UNITED STATES PATENT AND TRADEMARK OFFICE

APPLICATION NO.	FILING DATE	FIRST NAMED INVENTOR	ATTORNEY DOCKET NO.	CONFIRMATION NO.
10/620,360	07/17/2003	Chung-Fan Chiou	Q76519	8933
23373	7590	03/07/2006	EXAMINER	
SUGHRUE MION, PLLC 2100 PENNSYLVANIA AVENUE, N.W. SUITE 800 WASHINGTON, DC 20037			LEVKOVICH, NATALIA A	
			ART UNIT	PAPER NUMBER
			1743

Office Action Summary

DETAILED ACTION

FIG. 2

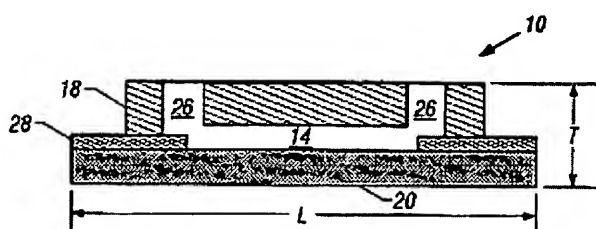
Zhao discloses a micro-fluidic chip which includes substrate 18 ['second member' – Ex.] comprising micro-channel 14 ['fillister' – Ex.], cover 20 ['first member' – Ex.] and electrodes 28 located both on the cover and in reservoirs 14 and 26 (see Figure 2).

Referring to claims, 5 and 20, Figure 2 also shows wells 26 [‘at least two openings’ – Ex.].
